December 27, 2018  
Serial: RA-18-0261

Shearon Harris Nuclear Power Plant, Unit 1  
Docket No. 50-400/Renewed License No. NPF-63

Subject: Response to Request for Additional Information Regarding License Amendment  
Request on Reactor Trip System and Engineered Safety Features Actuation  
System Instrumentation Trip Setpoints

RESPONSE TO REQUEST FOR ADDITIONAL INFORMATION

**Figure SRXB RAI 2-1 Demonstration Analysis Results: Minimum DNB**

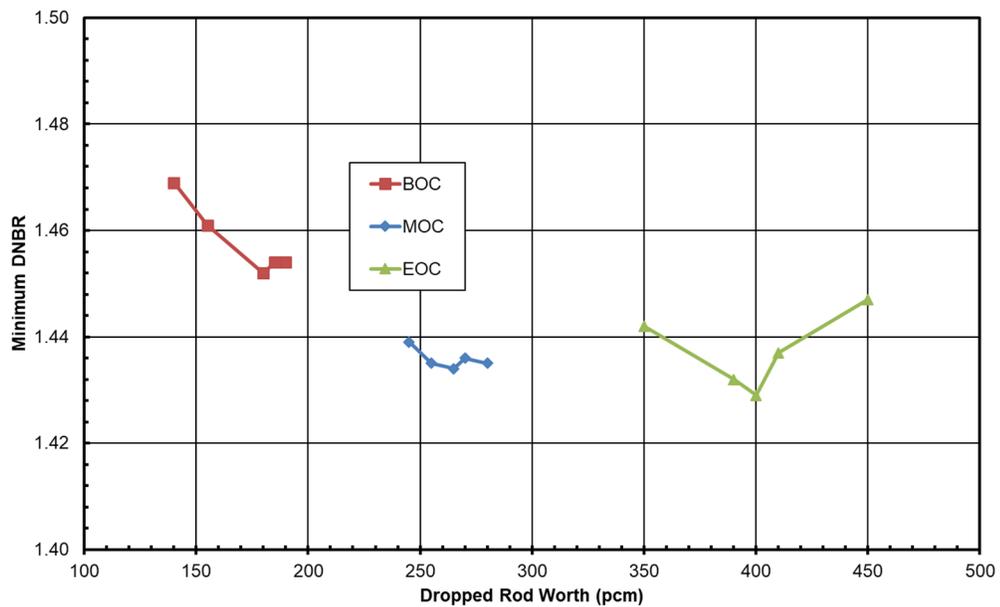
Please provide a discussion of the analysis of the dropped rod event performed with the Duke Energy methodologies and demonstrate that for cases without crediting the high power range negative neutron flux rate trip, the results of the dropped rod analysis meet the applicable Chapter 15 accident analysis acceptance criteria.

This representative dropped rod calculation shows that the high power range negative neutron flux rate trip is not needed. The results of the representative dropped rod analysis meet the applicable Chapter 15 accident analysis acceptance criteria (see Figure SRXB RAI 2-1).
